Access Compliance Report

Public Rights-of-Way

Intersection ID: 45984	Main Street: CHESTERBROOK_LN	Cross Street: MASON MILL_PL	Location:	N
ADA ID: 14CE34D31CDD	Ramp Type: PerpDiag	Initial Pass/Fail: Pass	Overall Compliance: No	Severity Score: 0
Codes/Mitigation Info/Possible Solution		Field Measurements/Component Compliance

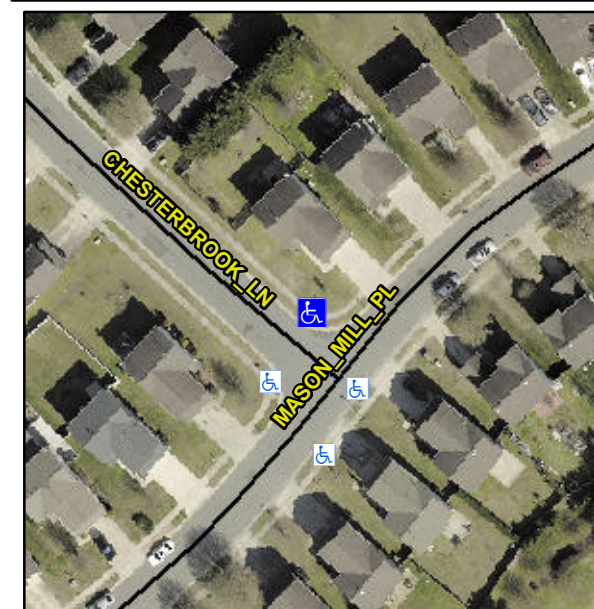
R304.2.1, R304.2.2-Perp, R304.3.2-Para, R304.5.3, R305.2

Compliance	Description	Data	Compliance	Description	Data
N/A	Ramp Length (in)	47.0	Yes	Ramp Slope (%)	7.4
Yes	Ramp Width (in)	48.0	Yes	Ramp XSlope (%)	2.0
N/A	Flare Type LT	Sloped	N/A	Flare Type RT	N/A
N/A	Flare Slope LT (%)	5.5	N/A	Flare Slope RT (%)	11.6
N/A	Flare Traversable LT?	No	N/A	Flare Traversable RT?	No
No	Landing Length (in)	43.0	Yes	DWS Provided?	Yes
Yes	Landing Width (in)	48.0	Yes	DWS Contrast?	Yes
No	Landing Slope (%)	4.4	Yes	DWS Length (in)	24.0
No	Landing X Slope (%)	2.8	Yes	DWS Full Width?	Yes
N/A	Landing Curb? (Y/N)	No	No	DWS Offset (in)	4.0
N/A	Shared Landing?	No			
Yes	Gutter Ponding?	No	Yes	Gutter Slope (%)	1.7
Yes	Gutter Lip Ht (in)	0.0	No	Gutter X Slope (%)	4.4
N/A	Painted X Walk1?	No	N/A	Painted X Walk2?	No
	X Walk 1 Direction	To SW		X Walk 2 Direction	To SE
N/A	X Walk 1 Width (in)	N/A	N/A	X Walk 2 Width (in)	N/A
	X Walk 1 Slope (%)	0.3		X Walk 2 Slope (%)	2.4
	X Walk 1 X Slope (%)	1.0		X Walk 2 X Slope (%)	5.0

N/A	Ramp inside XWalk1?	N/A	N/A	Ramp inside XWalk2?	N/A
	Road Slope (%)	3.6	N/A	Clear Space?	Yes
	Road X Slope (%)	1.0	N/A	Clear Space to XWalk (in)	N/A
Yes	Any Obstructions?	No	Yes	Storm Grate/Utility Hazard?	No
	Obstruction Type			Storm Grate/Utility Type	
		N/A			N/A
			Yes	Surface Condition? (G/P)	Good

Remove & Replace Curb Ramp With Two New Directional Ramps or Equivalent. Remove & Replace Gutter.
